LOUISIANA
POWER & LIGHT

Subject: Waterford 3 SES
Docket No. 50-382
MASONRY BLOCK WALLS

Enclosed is the additional information requested by the NRC reviewers. It is provided in the format of responses to the sixteen confirmatory items identified during the site visit. Once the material is given NRC review, LP&L is prepared to visit and discuss any further information or details on the Waterford 3 masonry walls construction.

SUBJECT: LOUISIANA POWER & LIGHT COMPANY
WATERFORD STEAM ELECTRIC STATION
1984 - 1165 MW INSTALLATION - UNIT NO. 3
FOLLOWUP ACTION PLAN FOR CLOSURE OF MASONRY
BLOCK WALLS CAT ITEM 6.2/6.3

OFS NO. _____ DEPT. EE NO. 10005CLIENT CP&CPROJECT WATERFORD SES #3SUBJECT CONC. BLOCK WALL (H2 WALL @ EL-35.0)ITEM 5H2 WALL @ EL-35.0 LOOKING WEST

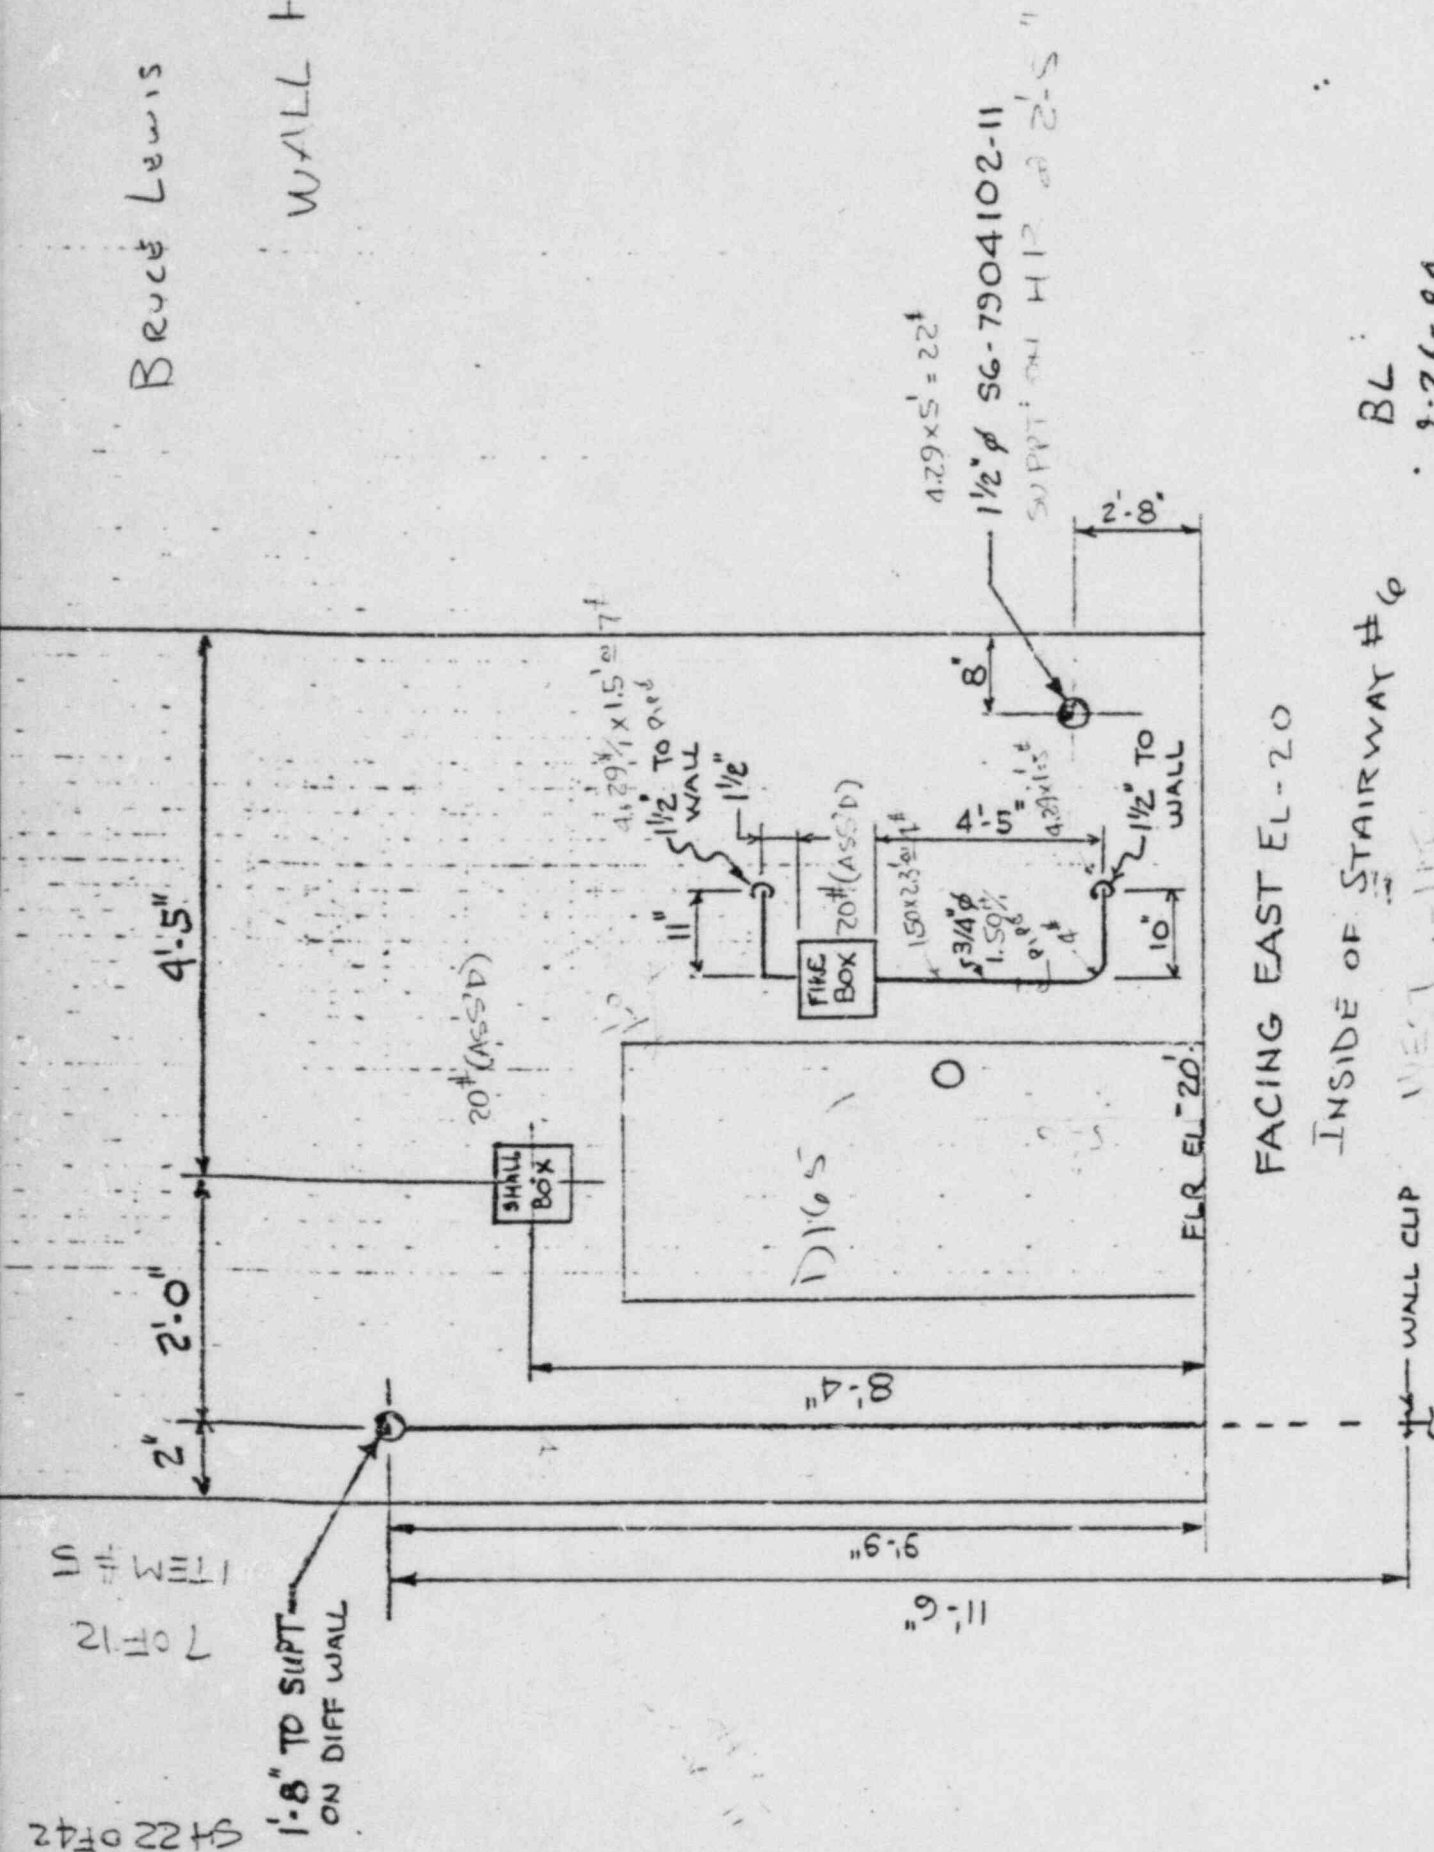
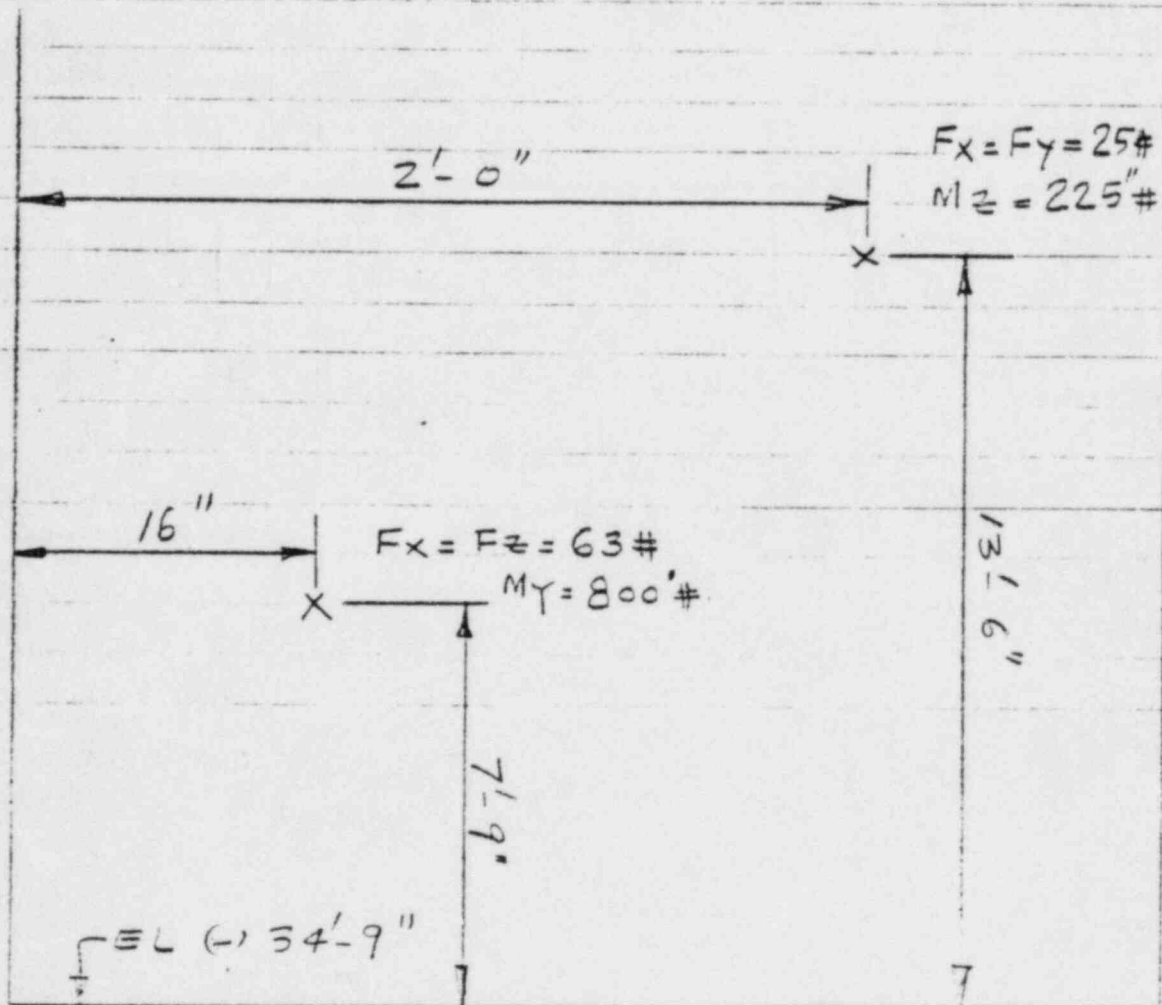
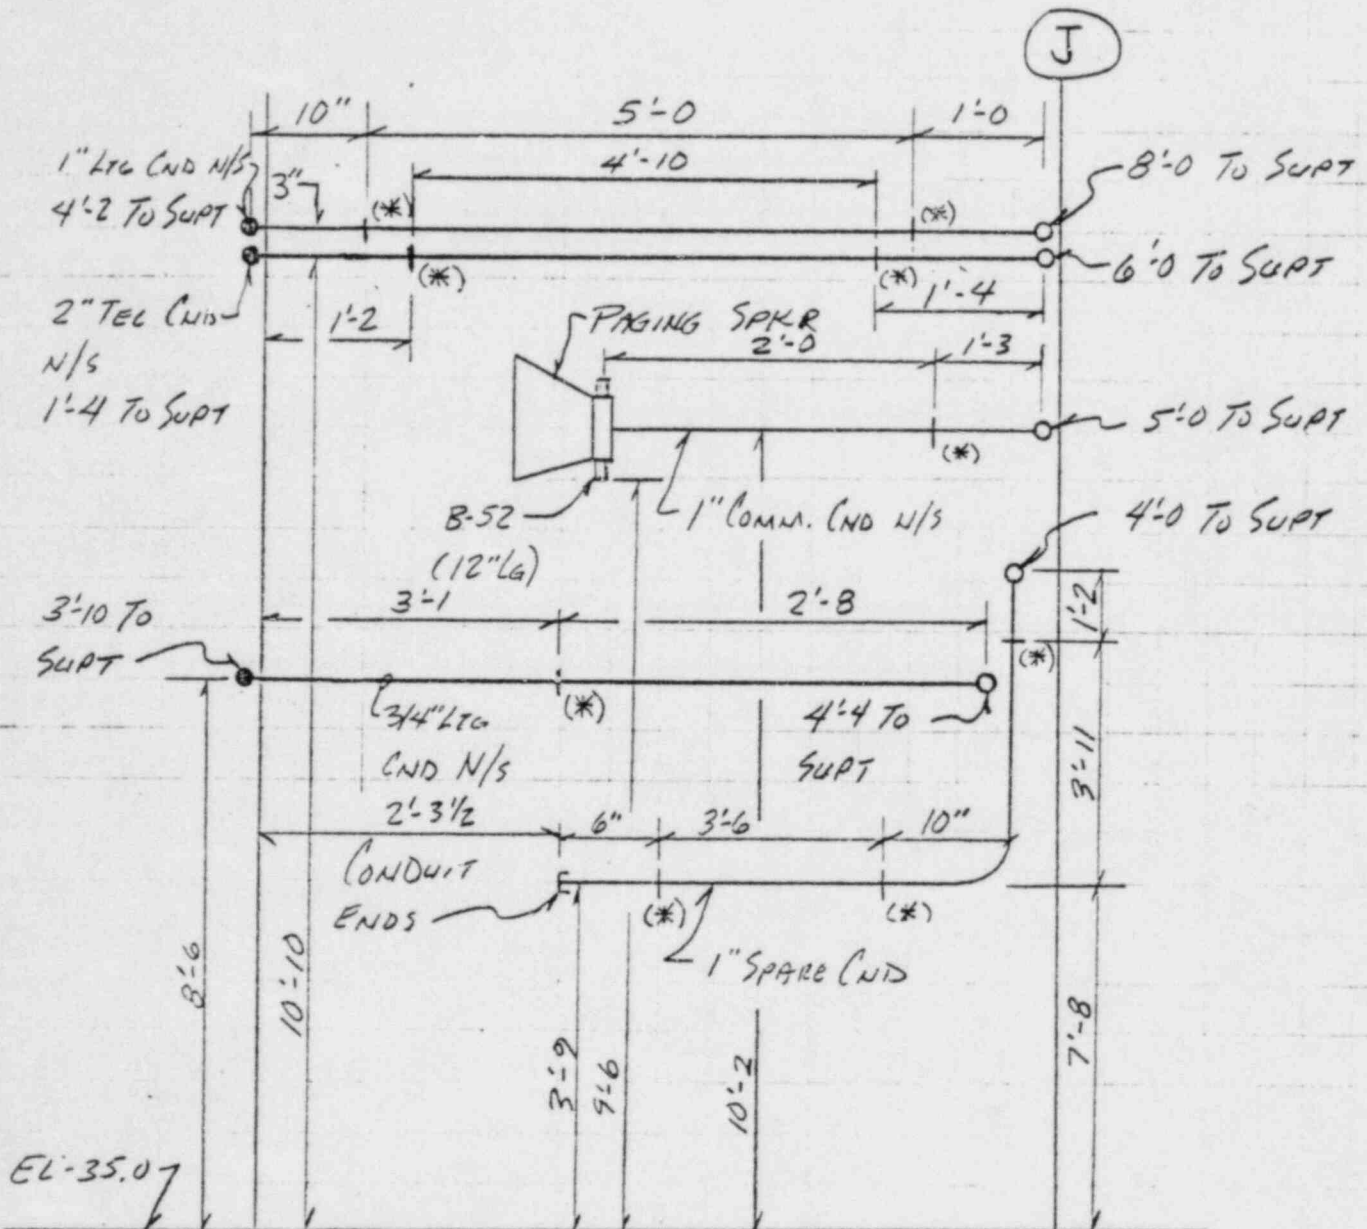
ITEM NO.	NRC REVIEW STATUS	QUESTION	RESPONSE
5.	Open	Verify the structural adequacy of Masonry Walls when miscellaneous non-seismic loads are considered. Select Walls S1, H2, H13, and W29 for this analysis.	Calculation Package No. 5 provides verification of wall S1. Verification of walls H2, H13 & W29 will be provided by 10/8/84.

Therefore the drawing can be revised to denote block pattern and to be accepted as-built. WALLS H7 & H6 ARE THE EXCEPTION AS THAT THE BLOCKS ARE OF RUNNING BOND INSTEAD OF STACK

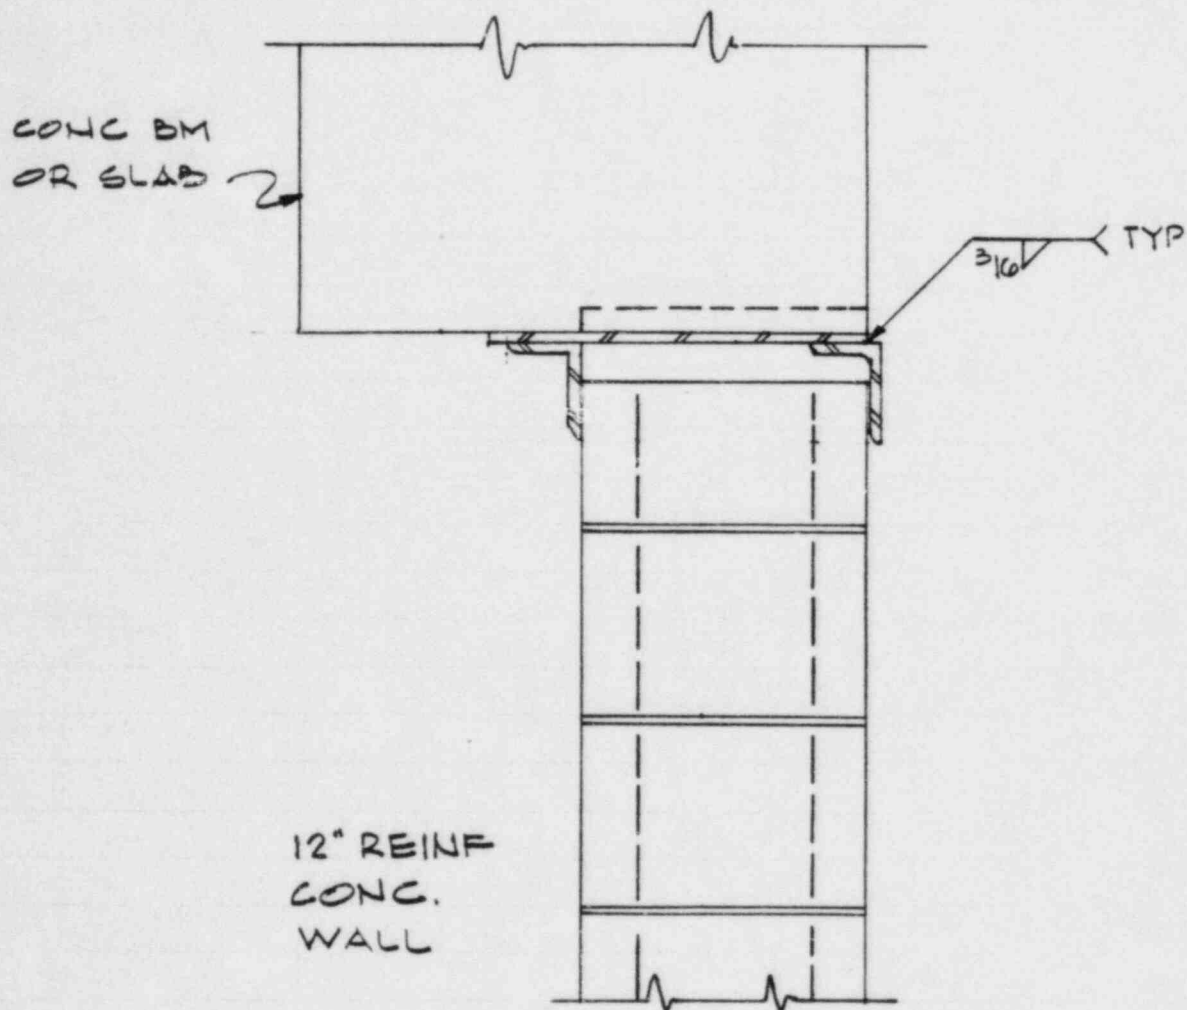
8.	Open	Confirm that block placement on wall H6/H7 is the exception. In this case blocks are staggered in lieu of vertical stacking as is typical for other hollow block walls. Verify structural adequacy of detail DN which is not presently covered in CAT Response.	Confirmation of acceptable block placement is provided in attached Memo No. ES-10130-84. Structural adequacy of detail DN is verified as noted in the attached Calc. Package No. 8.

The concrete masonry block wall H6 and H7 located at Elevator Machine Room EL.-34.75' are constructed with running bond pattern instead of stack bond. The walls are 8" concrete block above the 1'-10 concrete curb from EL. -32.67' to EL. -24.67 with a 6" slab over. They are reinforced with vertical reinforcement @ 48" o.c. in the block cells and with duro-wal every other courses. The structural analysis indicates that the walls are adequate for the applied loads.
